# Access Compliance Report Public Rights-of-Way (Curb Ramps)

Main Street: THEODORA\_DR Cross Street: PROSPECT\_AVE Location: SE

ADA ID: RPRK211011115627 Ramp Type: Type 7 - Directional 2 Initial Pass/Fail: Fail Overall Compliance: No Severity Score: 30

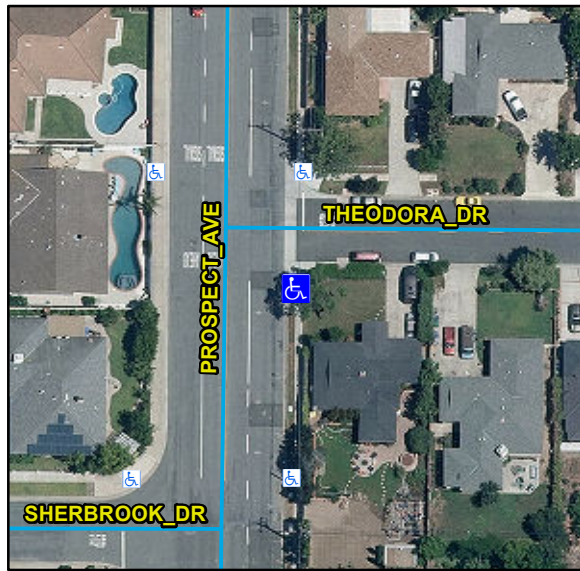
| Compliance | Description            | Data       | Compliance | Description        | Data |
|------------|------------------------|------------|------------|--------------------|------|
| No         | Obstructions Present?  | Yes        | N/A        | Utilities Present? | No   |

| Compliance | Description                   | Data       | Compliance | Description                   | Data |
|------------|-------------------------------|------------|------------|-------------------------------|------|
| No         | Ramp Cross Slope (%)          | 12.7       | N/A        | Flare Traversable LT          | N/A  |

Remove & Replace Entire Ramp.

R304.5.3, R302.3, R402.2, STD 1115
